Amendment-4 (dated 17.07.2025) to RFP Documents for Transmission Service Provider to establish “Inter-regional (NR-WR) Transmission System strengthening to relieve the loading of 765 kV Vindhyachal-Varanasi D/c line” through tariff based competitive bidding process.

Proposed Communication for "Inter-regional (NR-WR) Transmission System strengthening to relieve the loading of 765kV Vindhyachal-Varanasi D/c line"

Figure F.1

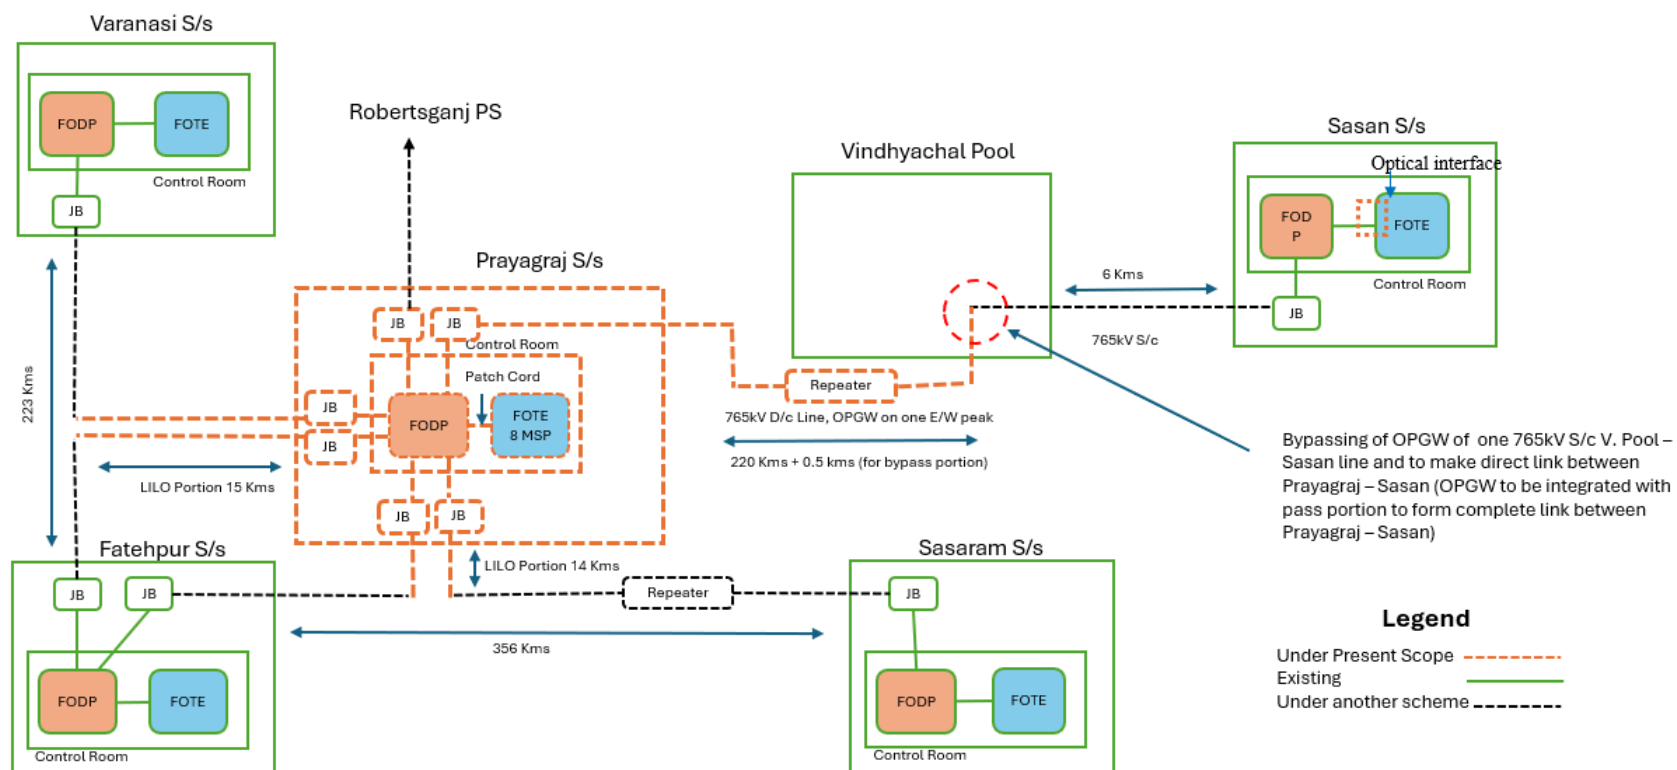
3.	Figure F.1		Revised Figure is attached at Annexure - D
4.	Clause B.1.2 of specific technical requirement of s/s.	New clause added:	B.1.2 Switching scheme Notes:- (ix) 765 kV Bay configuration at Prayagraj S/s shall consist of 04 Nos. of full diameter (one diameter consists of two Nos. Main and associated Tie bays) for termination of Bus Reactor/Line bays.
